Subject: Draft Regulatory Guide DG-8022 (Proposed Revision 1 to Regulatory Guide 8.15), "Acceptable Programs for Respiratory Protection."

**Reference:** Draft Regulatory Guide DG-8022

Subject: Wyoming Mining Association Comments on "Draft Regulatory Guide DG-8022, Proposed Revision 1 to Regulatory Guide 8.15, "Acceptable Programs For Respiratory Protection" July 1998

**Subject:** Comments on Draft Regulatory Guide DG-8022 (Proposed Revision 1 to Regulatory Guide 8.15), "Acceptable Programs for Respiratory Protection"

Figure 1: Leak rate (cc/min) at various breathing resistance's (mm of water)

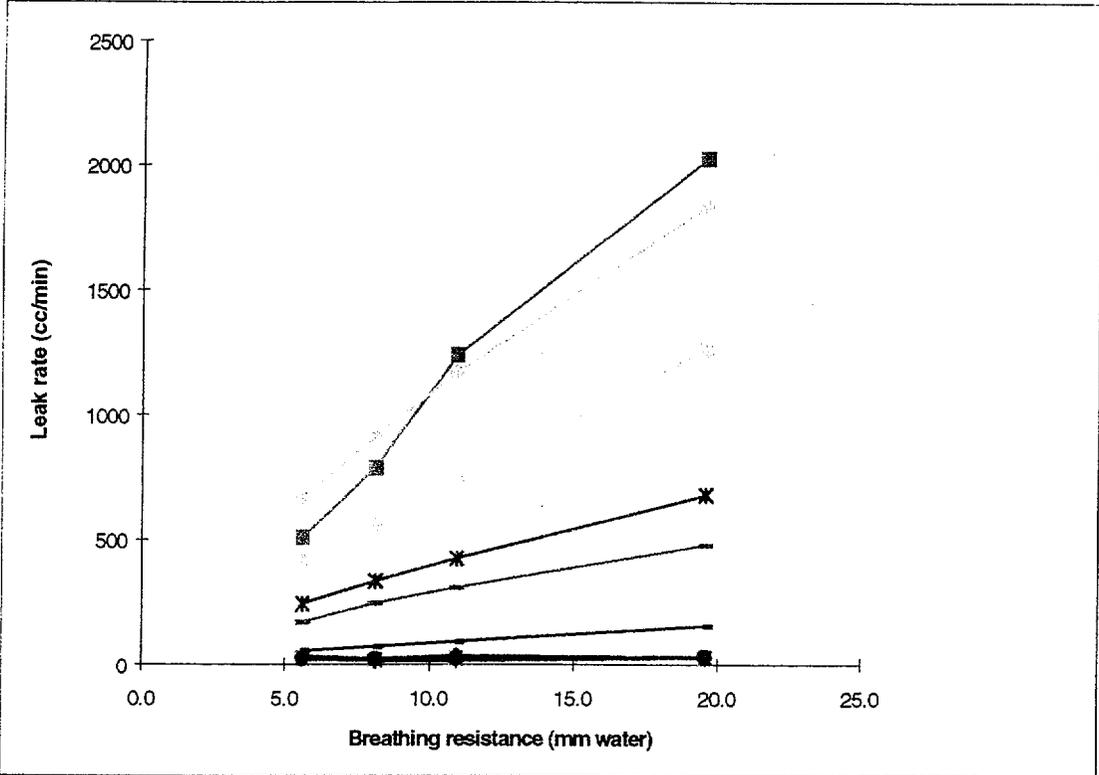
Increasing filter efficiency leads to an increase in filter breathing resistance. Increased breathing resistance leads to an increase in face seal leakage. Figure 1 below shows this relationship. A leak rate of 500 cc/min is equivalent to a fit factor of ~ 50 to 100. An increase in breathing resistance of 2 mm with a leak rate of 500 cc/min would decrease the fit factor to ~30- 60. The increase in face seal leakage may negate any decrease in exposure that could occur by use of a filter with higher filter efficiency.
